CJC:70002

FIXED SELF-TEST PRISM
AND IMPROVED TELESCOPE SEAL

PROPOSED INCREASED FIELD OF VIEW

INCREASED FIELD OF VIEW STUDY

FIGURE 5 - PRESENT AND MODIFIED OPTICAL SYSTEMS

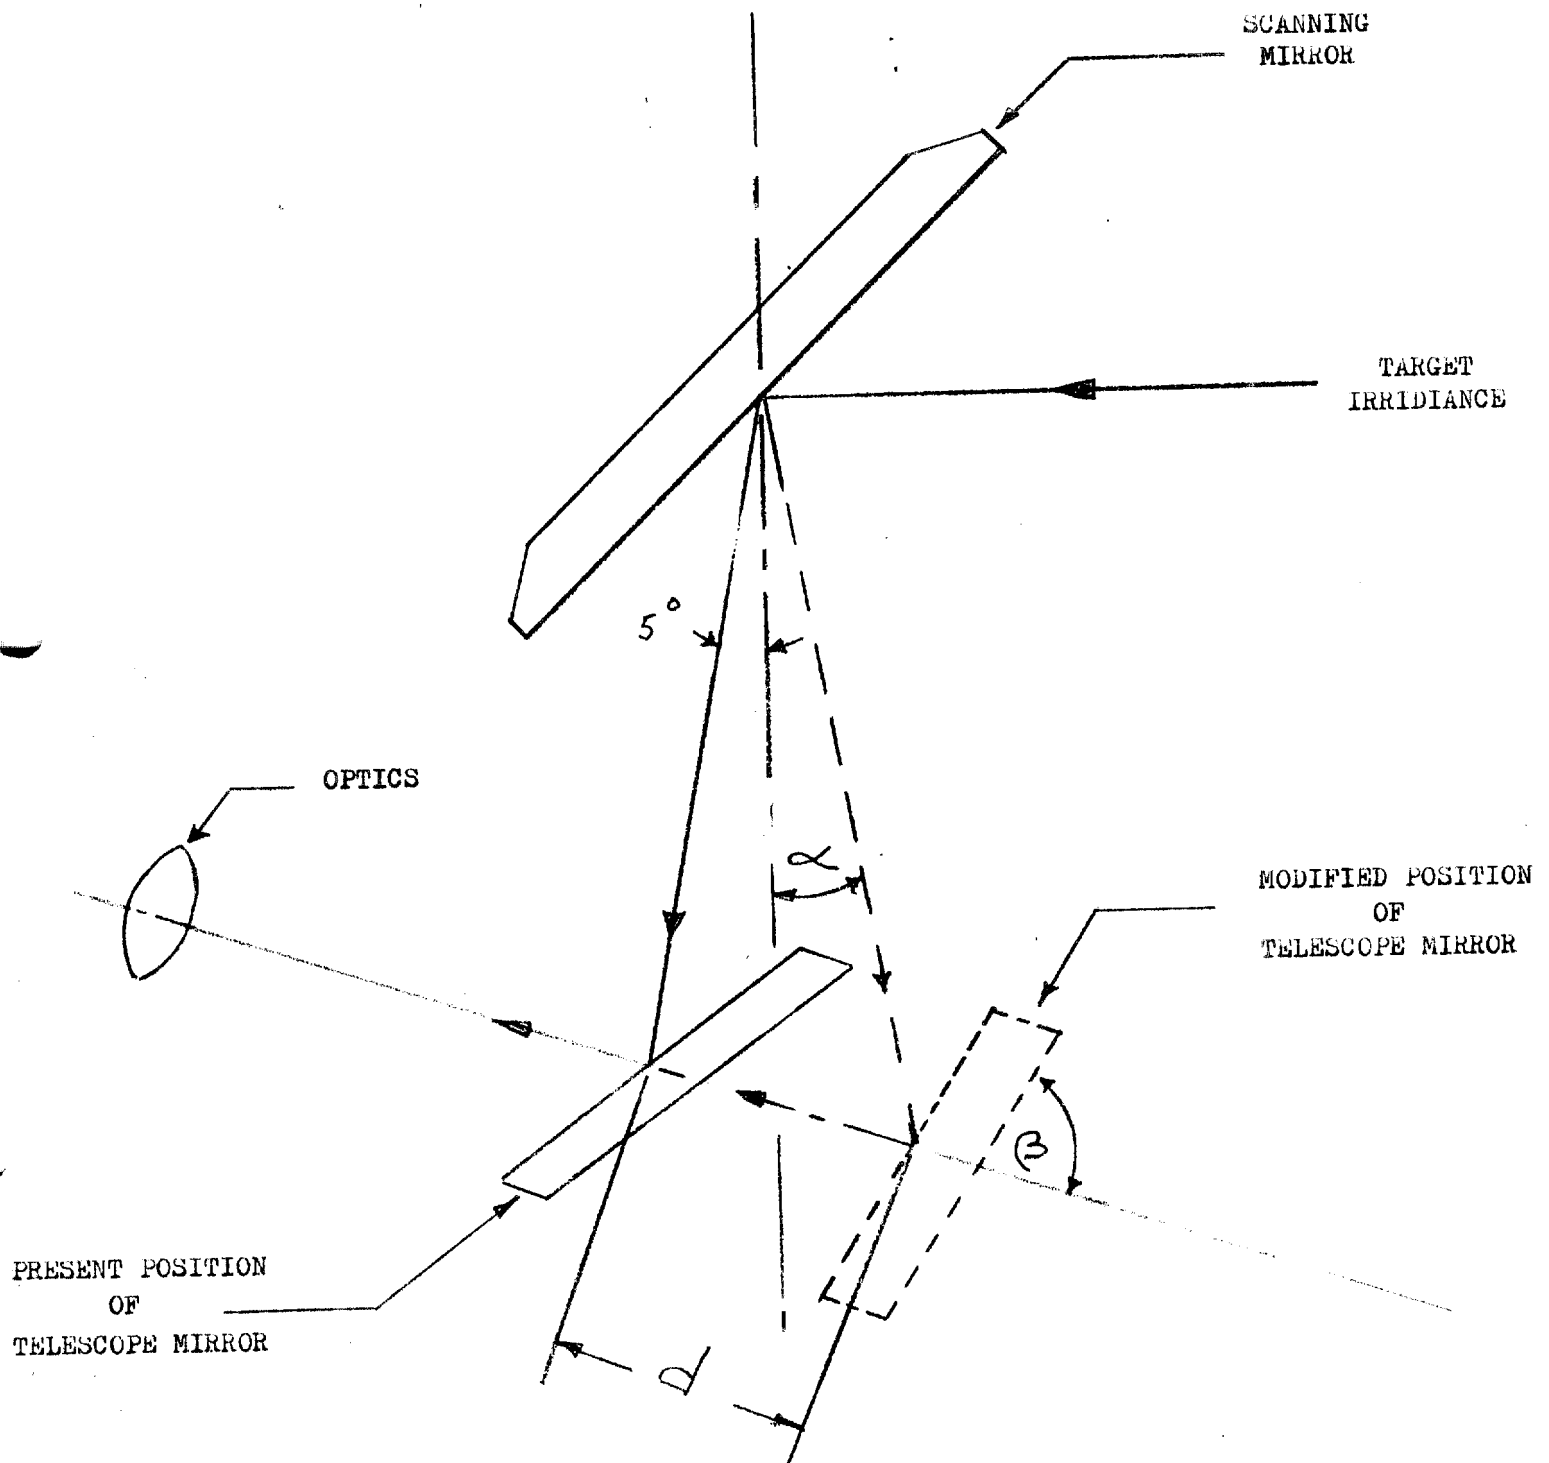
In the present system the telescope reflecting mirror is located 5° behind the vertical axis of the scanning mirror as shown in Figure 5. This causes an azimuth look angle of less than the azimuth mechanical angle according to the equations

A review of the scan pattern equations reveals that the azimuth look angles can be increased by repositioning the telescope reflecting mirror in front of the vertical axis of the scanning mirror. The azimuth look angle equation changes from

where α is the offset angle in front of the vertical axis of the scanning mirror as shown in Figure 5.

For an offset angle α of $+5^{\circ}30'$ the telescope reflecting mirror had to be moved a distance d of 0.578 inches down the axis and tilted to an angle β of $53^{\circ}15'$ with respect to the axis.

FIGURE 6 - SCAN PATTERNS

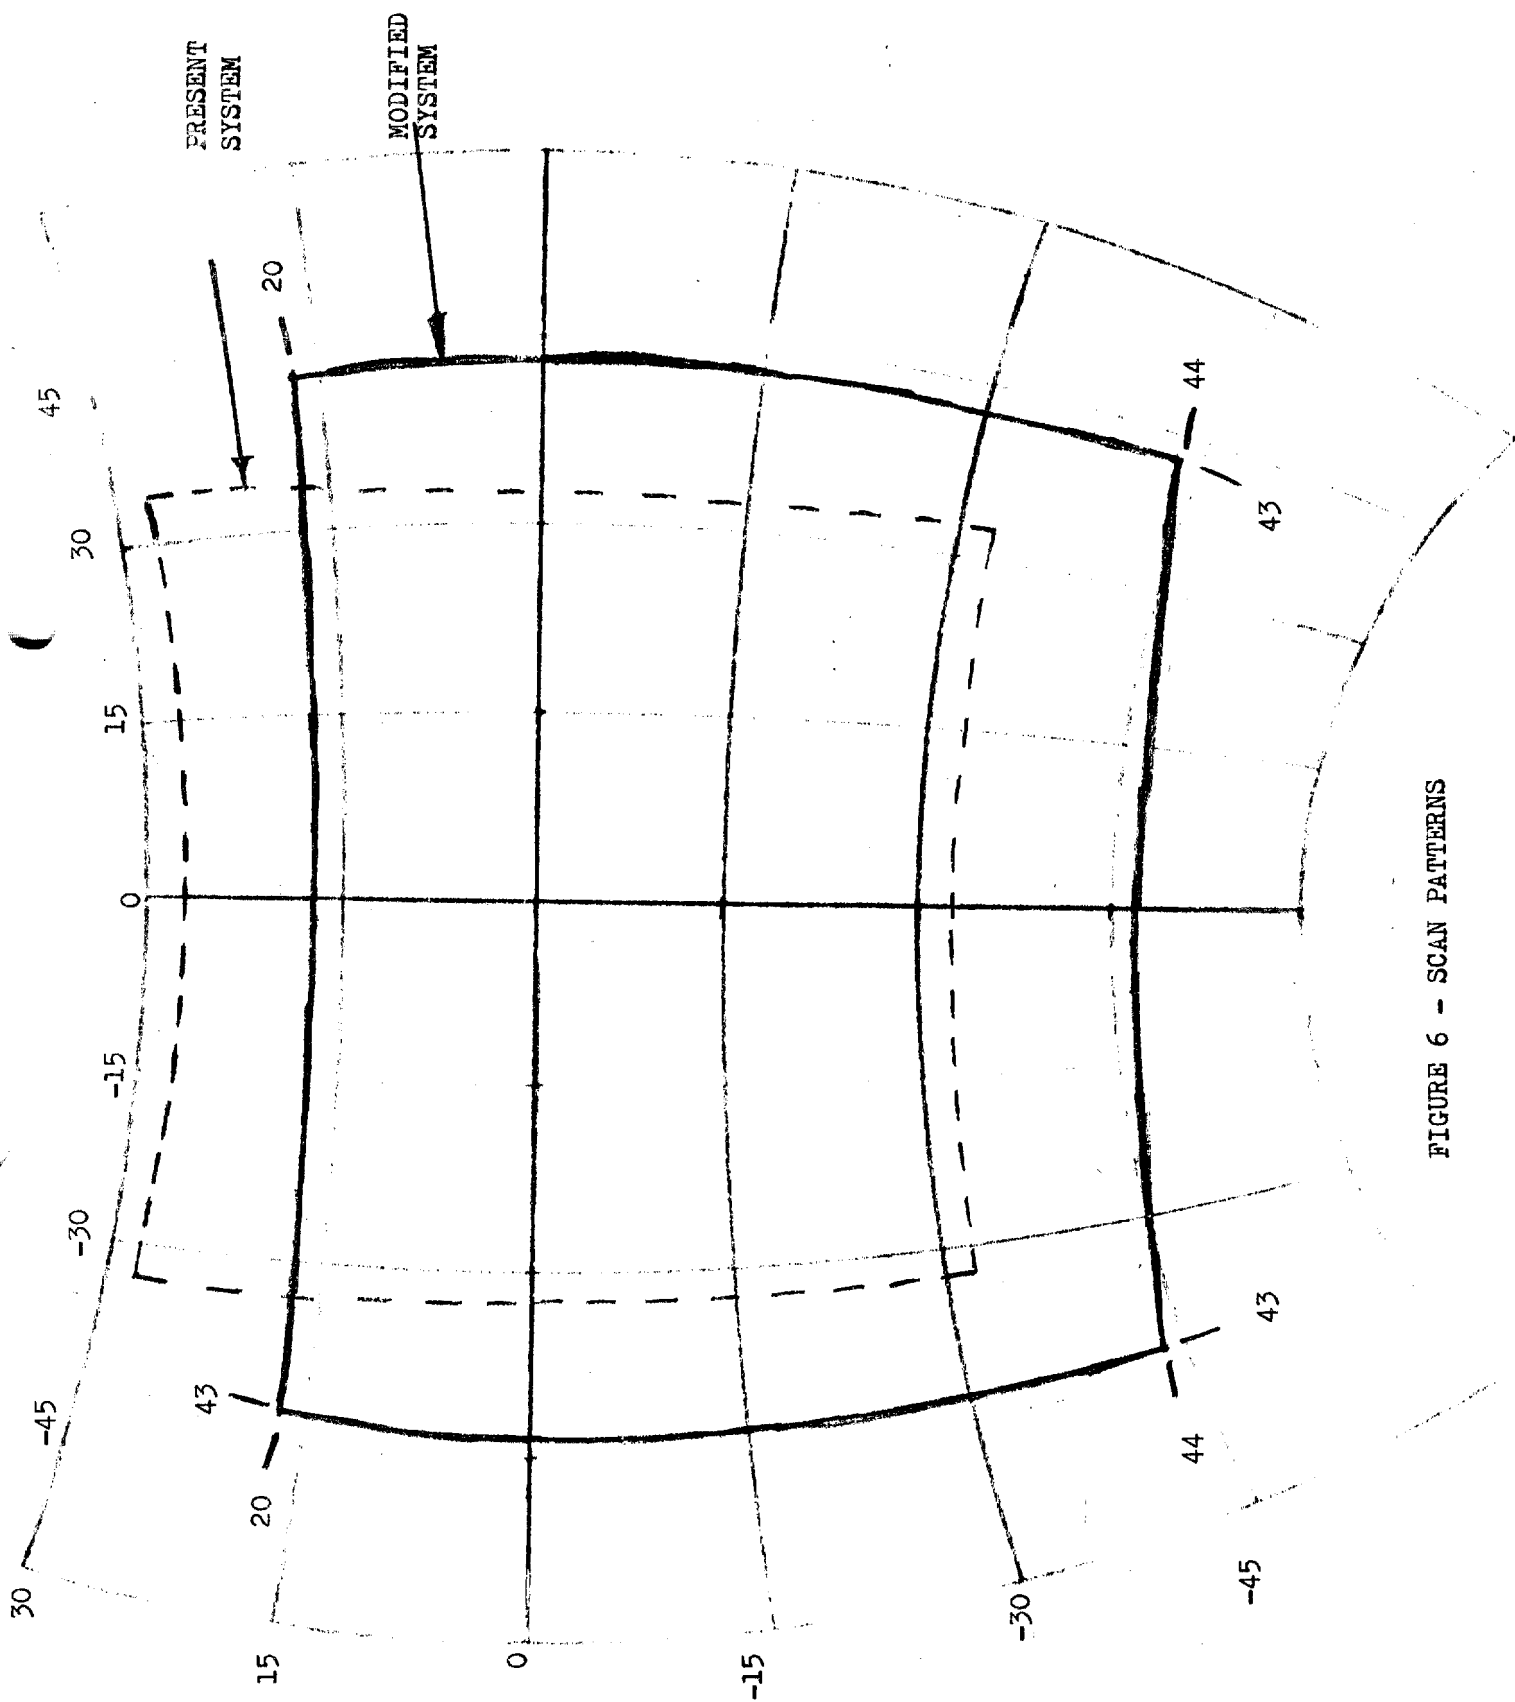
Figure 6 shows the scan pattern of the modified optical system along with the pattern of the present system displayed on a spherical coordinate system.

The entire modified pattern is shifted down $10^{\circ}30'$ from the original pattern due to the change in offset angle of the telescope reflecting mirror.
